August 19, 2016
BOARD OF COUNTY COMMISSIONERS
ORANGE COUNTY, FLORIDA
IFB NO. Y17-702-CC/ADDENDUM NO. 2
REGIONAL HISTORY CENTER CHILLER & COMPUTER ROOM AIR
CONDITIONING UNIT REPLACEMENT

This addendum is hereby incorporated into the bid documents of the project referenced above. The following items are clarifications, corrections, additions, deletions and/or revisions to, and shall take precedence over, the original documents. Underlining indicates additions, deletions are indicated by ~~strikethrough~~.

SHEET INFORMATION:	
JOB No. 100048247	Date Issued: 05/31/16
Designed By: KAR	Sheet Number:
Checked By: DLH	M-202
OC Review: T.J.F.	
Phase: BID

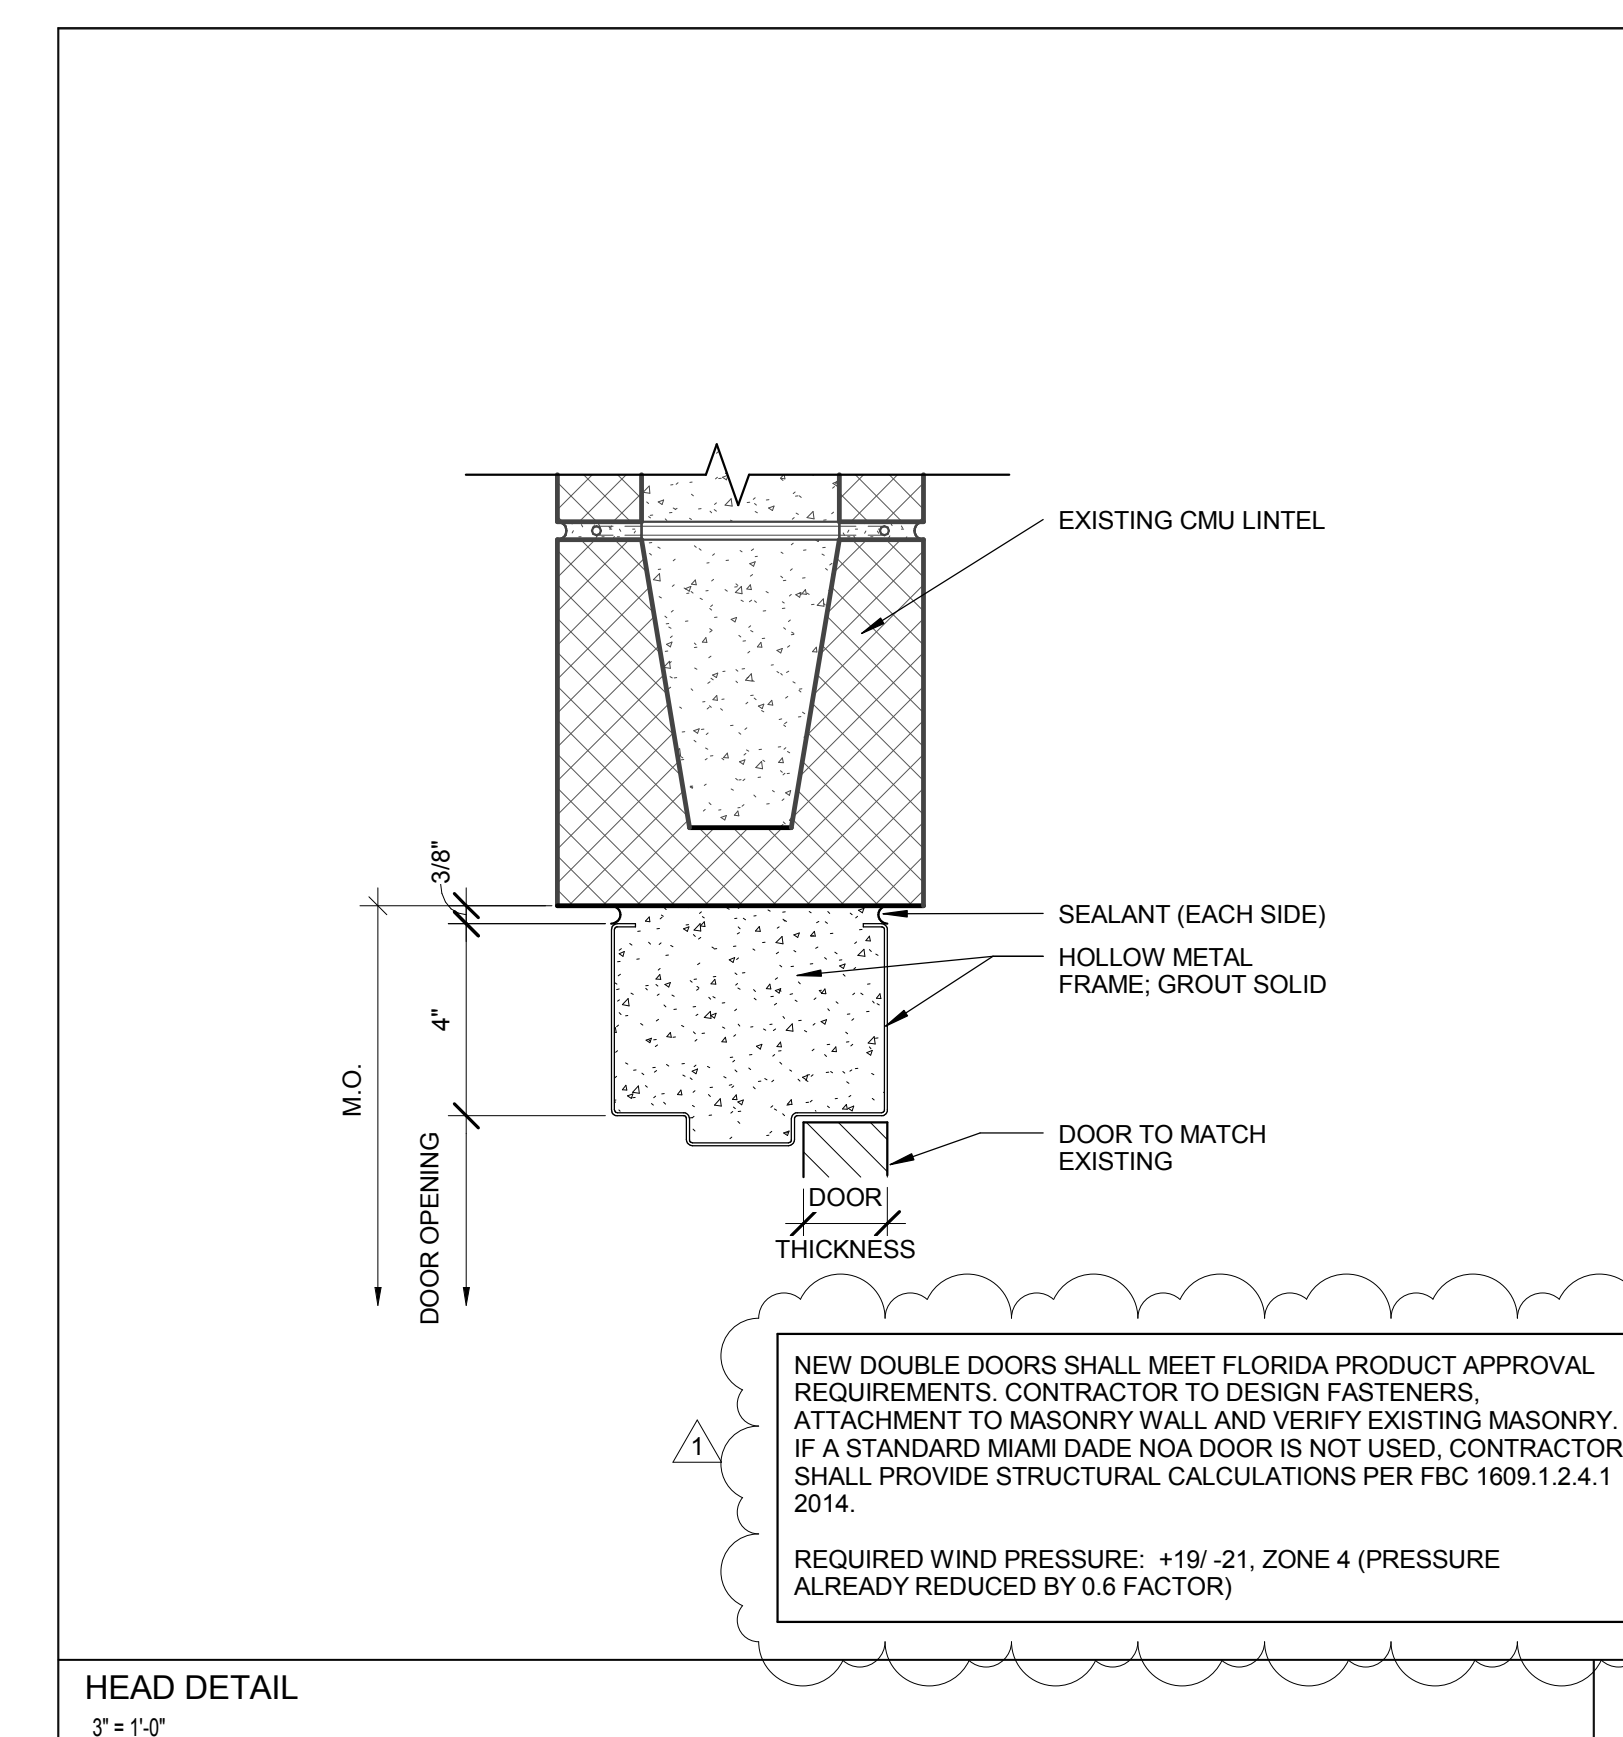
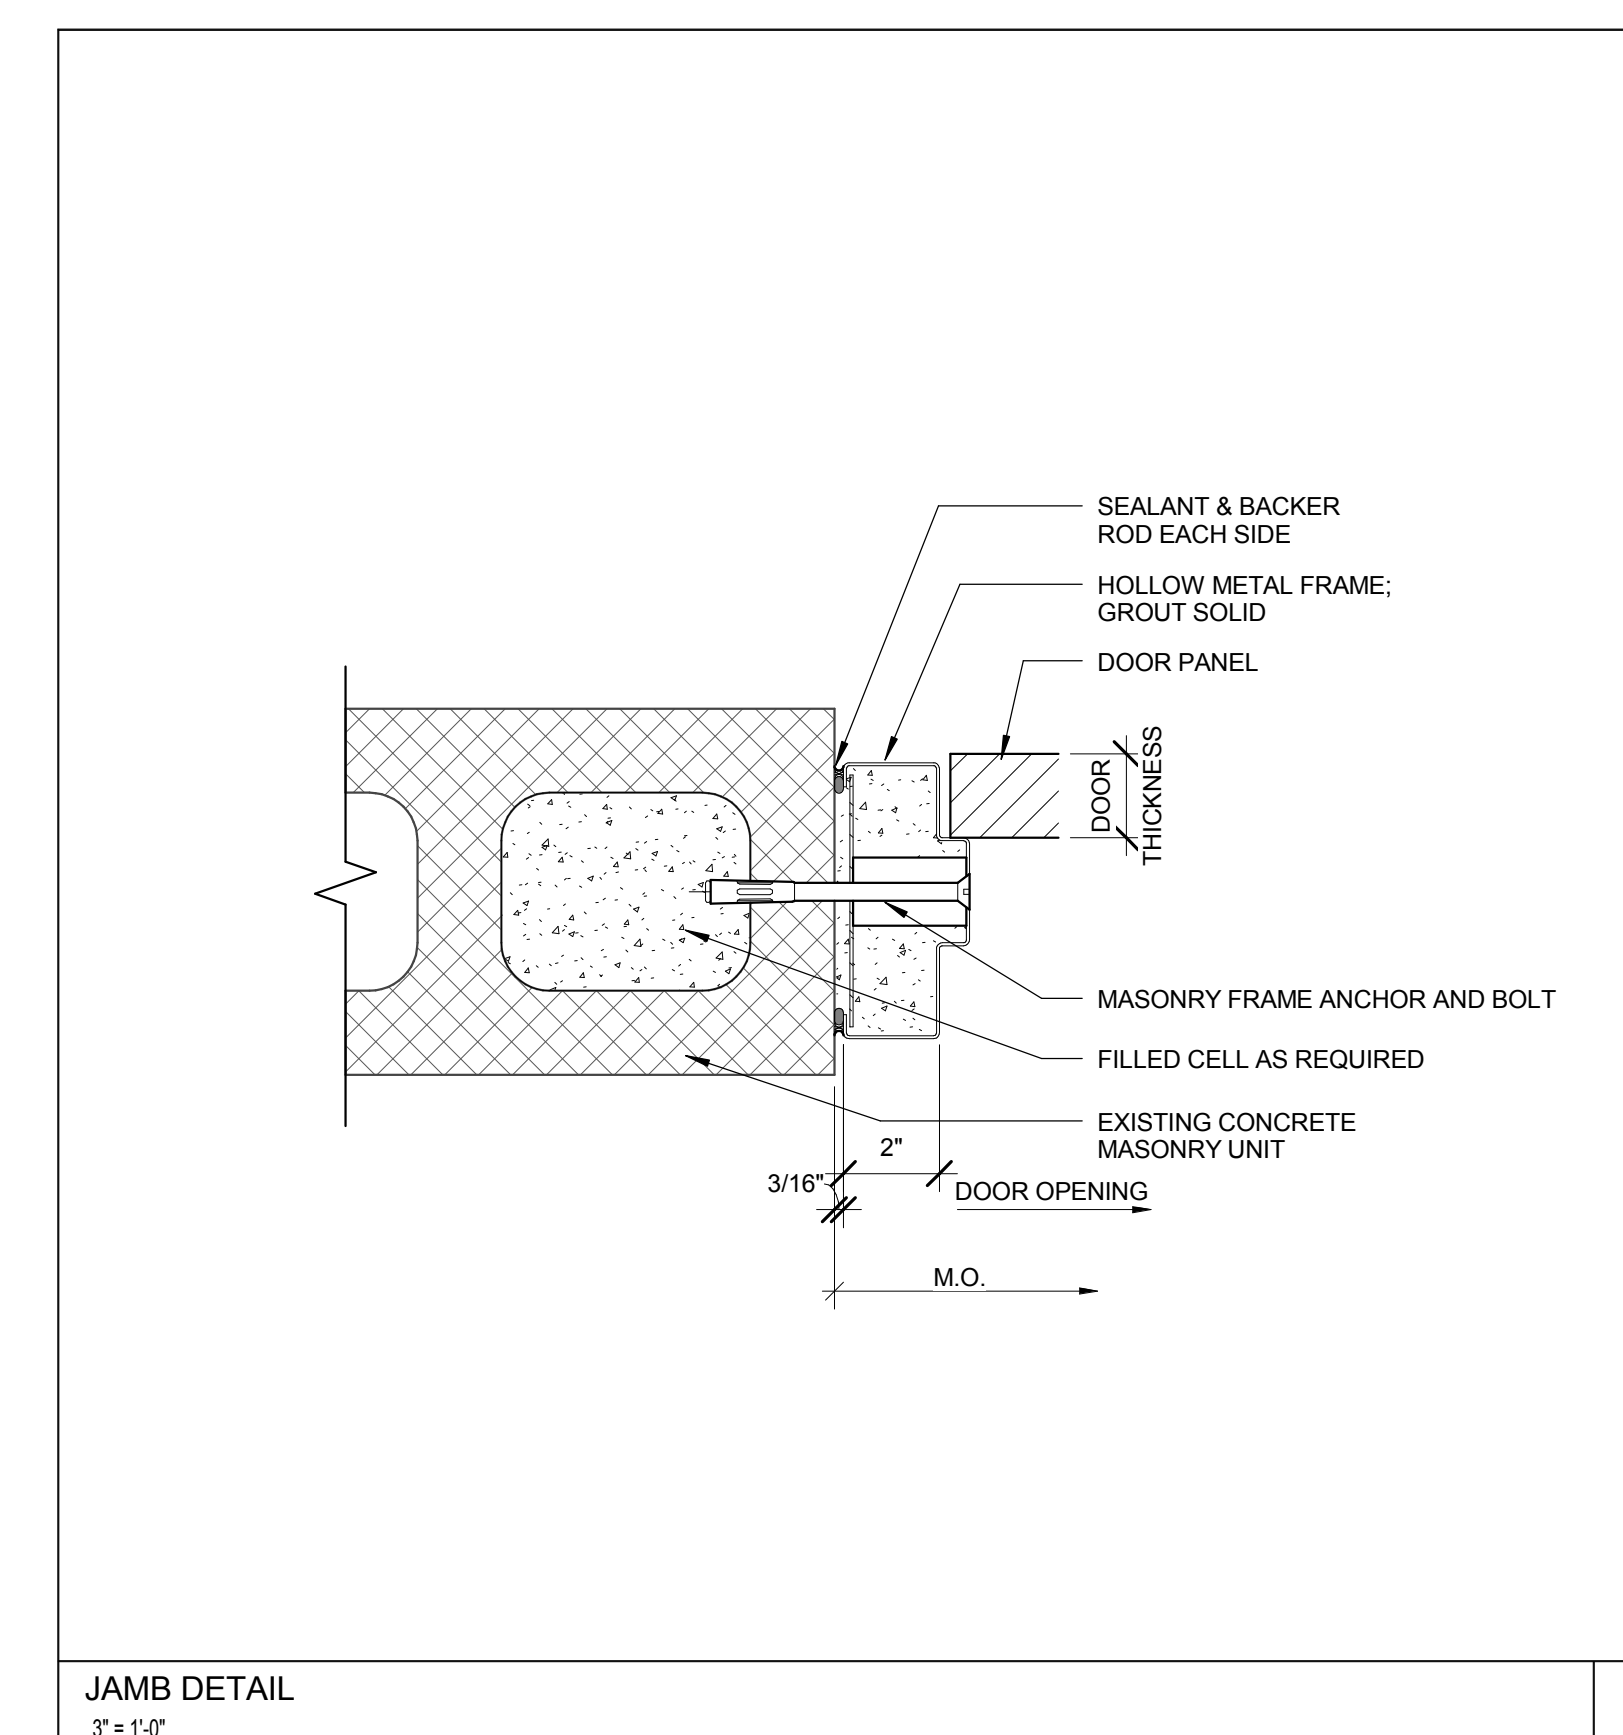
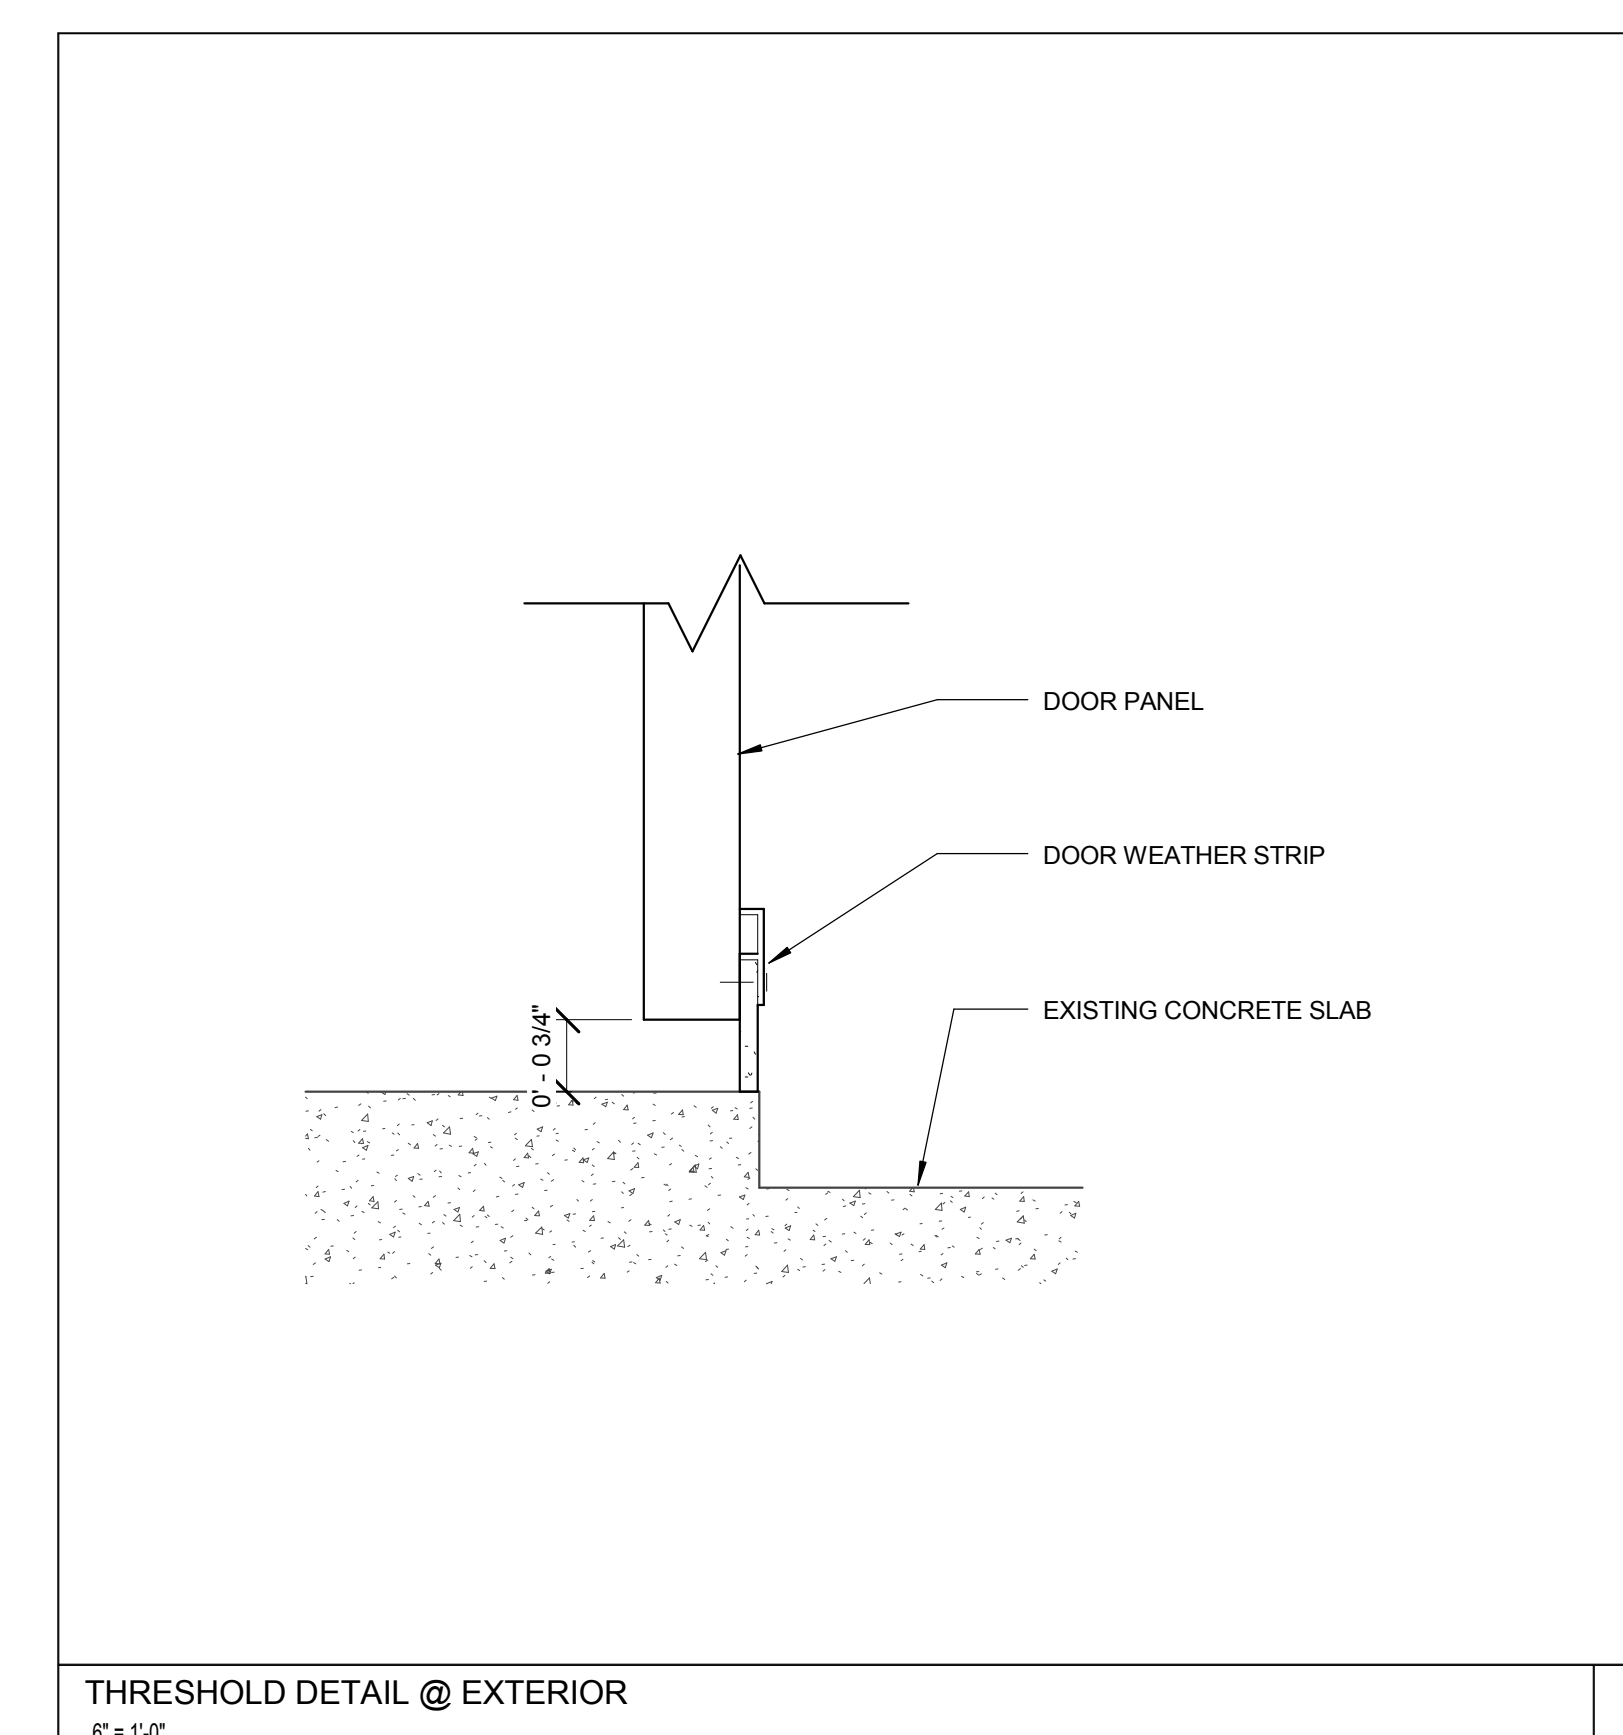
- M-202 HVAC Details (Double Door design requirements added to Detail 1. Contractor to provide Florida Product Approval.
- E-001 (Voltage drop calculations have been added. A load summary for the building main switchboard and panelboard schedule for panel EM5B have been added).
- EP-101 (Existing receptacle has been added).
- EP-102 (Existing receptacles have been added).
